Memorandum

Subject: Review of Z2026000081
Applicant Name: Ignacio Serrate and Vivian R. Serrate

The project is located at 8401 SW 94th Street, in unincorporated Miami-Dade County.

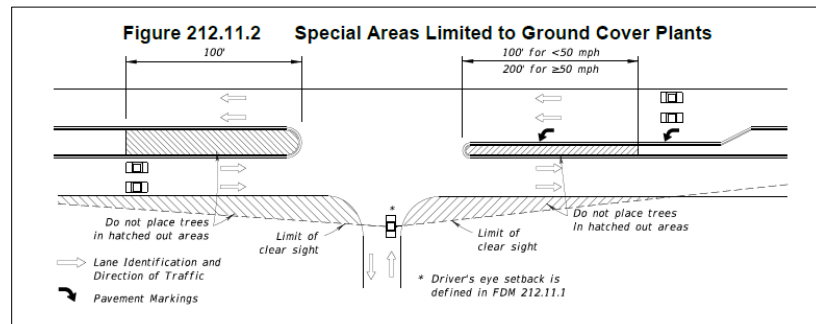
1. Exit driveways must comply with clear sight visibility requirements for both pedestrians and vehicular traffic. Provide clear sight visibility triangles on the site and landscape plans to demonstrate compliance with these requirements. Please ensure to clearly illustrate both (pedestrian and vehicular) sight triangles following the MDC Traffic Operations Manual and FDOT Standards. Note that according to the latest FDOT FDM manual Section 212.11.6, trees may not be placed within the hatched-out areas of the sight triangles, as shown in the figure below.
